MORGAN SHEET METAL ADDITION

Re: S/D 96-59 Final Plat of the MORGAN SHEET METAL ADDITION

CASE NUMBER: S/D 96-59 - MORGAN SHEET METAL ADDITION

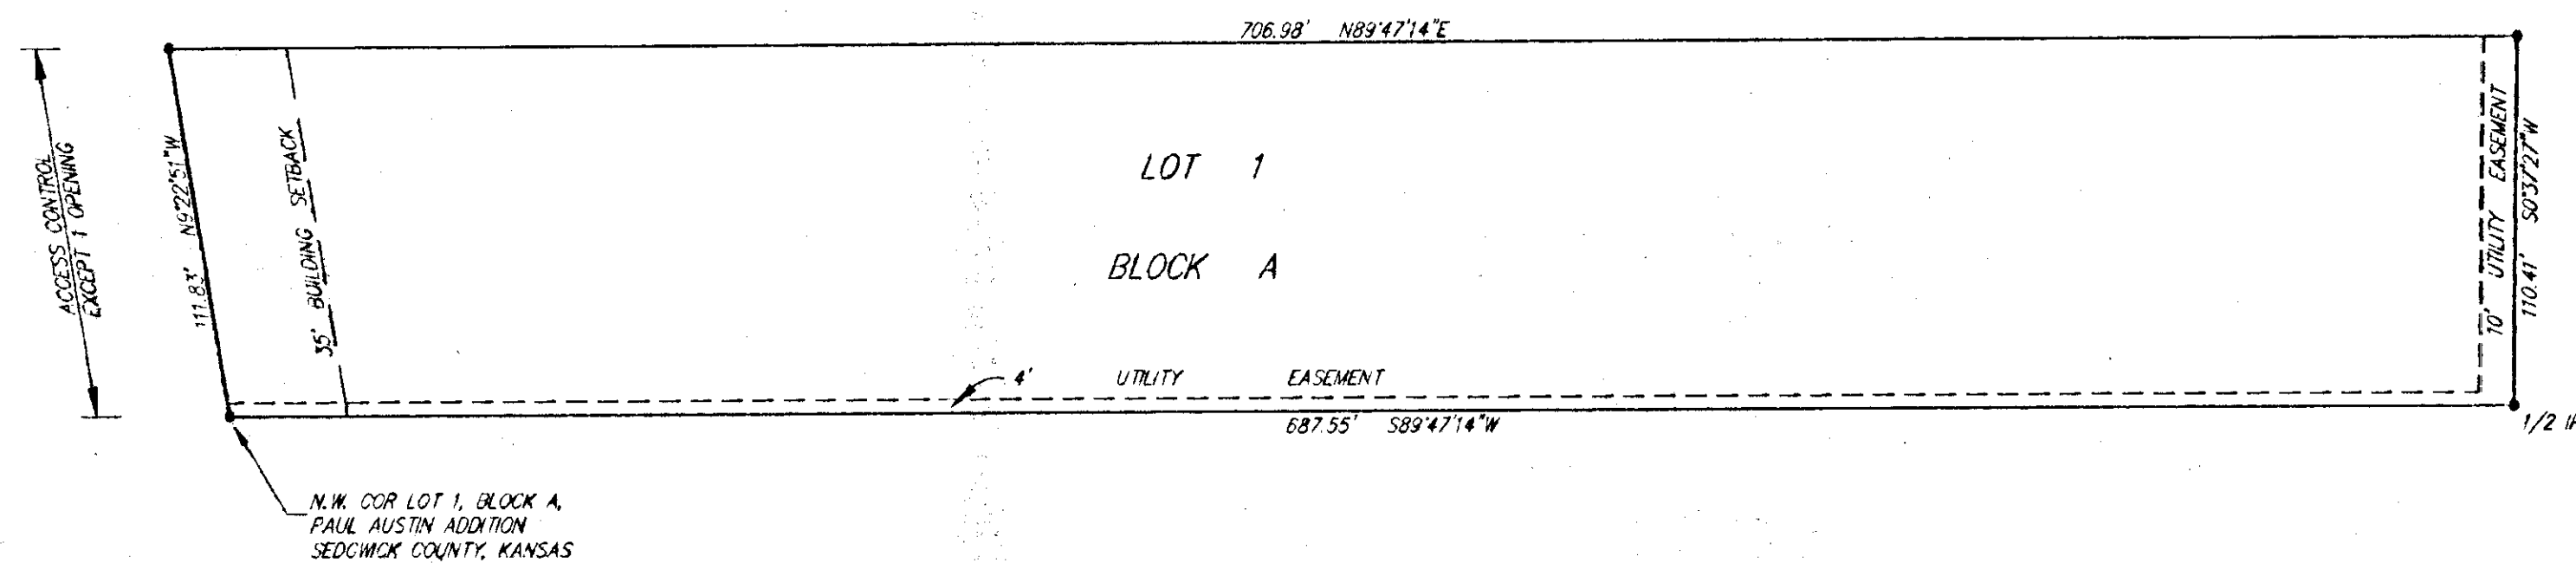
- D. The final plat tracing shall indicate the platting of the 35-foot building setback from K-15 through the existing building which encroaches into the setback area. While the platting of this building setback does not preclude the property owner from maintaining or remodeling that portion of the building within the setback area. The building cannot, however, be enlarged within the setback and, if the building is removed, any new building construction must observe the platted building setback.

- E. The final plat shall reference a tie point to a previously platted lot corner or section corner.
- F. On the final plat tracing, the legal description shall be corrected to note "the south 110.4 feet..." (not fet).

- D. The final plat tracing shall indicate the platting of the 35-foot building setback from K-15 through the existing building which encroaches into the setback area. While the platting of this building setback does not preclude the property owner from maintaining or remodeling that portion of the building within the setback area. The building cannot, however, be enlarged within the setback and, if the building is removed, any new building construction must observe the platted building setback.

- E. The final plat shall reference a tie point to a previously platted lot corner or section corner.
- F. On the final plat tracing, the legal description shall be corrected to note "the south 110.4 feet..." (not fet).
